**PLANNING COMMISSION MEETING**

**STAFF REPORT**

Item  
**Mall of American Transit Station renovation**

**Request:** Major revision to the Mall of America Final Development Plan for the renovation and expansion of Metro Transit's Mall of America Transit Station

PROJECT NO. 62317
SHEET NO. <b>C 3.01</b>

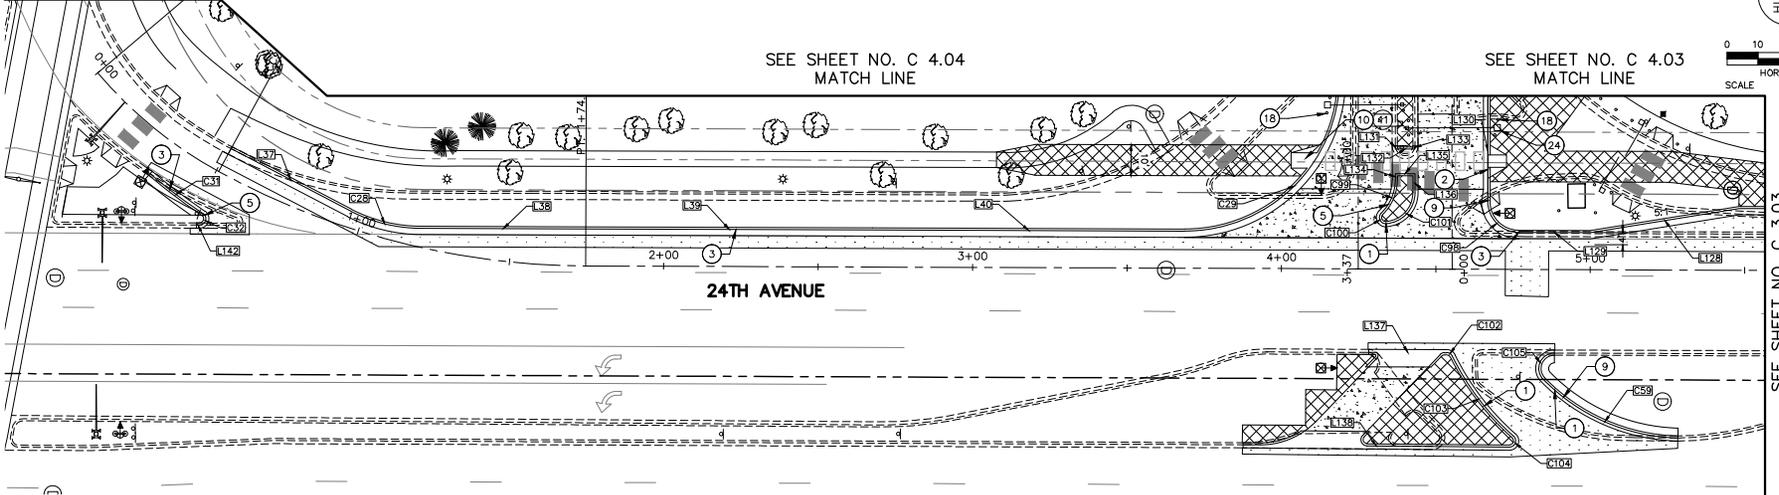
- 15) The saw cut shown on C2.01 is in the wheel path of the SB lane. Extend the cut to be the full lane width or shorten it so it is on the lane line. Similarly check the tire path versus the joint on sheet C3.02.

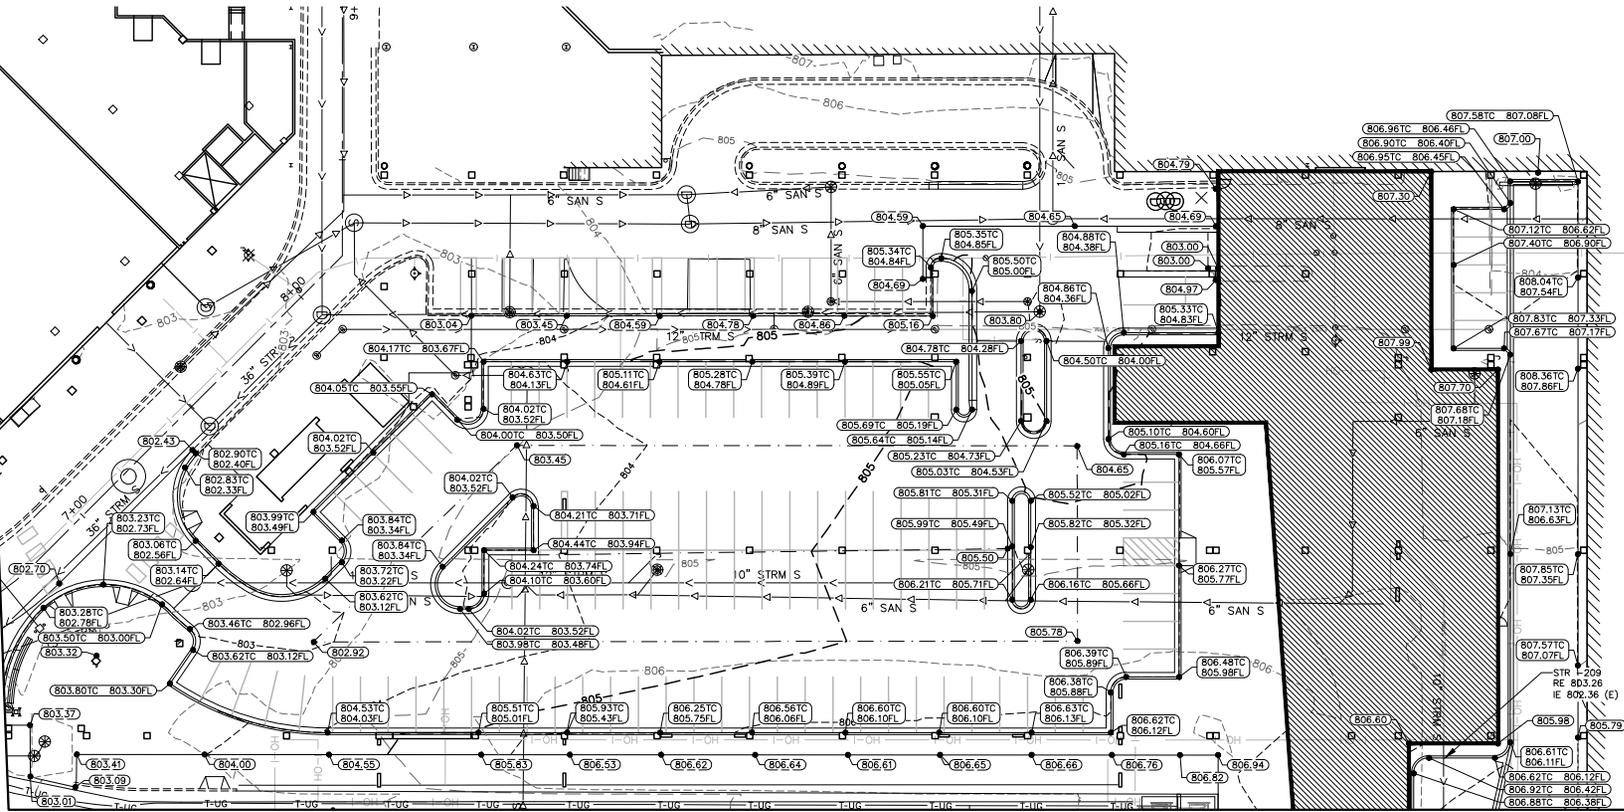
- 4) Revise the profile on sheets C5.02 and C5.03 so that it matches the plan view.
- 5) Do not install the new hydrant on the storm sewer for future maintenance.

- 20) Show median curb repair on sheet C3.03 for both sanitary and watermain work.
- 21) The catch basin in the median is shown for removal on C2.02 but still shows up on sheet C5.02 and C5.08. Please provide storm calculation that show the existing storm sewer and inlet capacity on 24th Ave works. Also if a new structure is not needed please remove the CB lead. Verify the storm pipes in this area. It appears that there are pipes flowing both north and west from the structure.
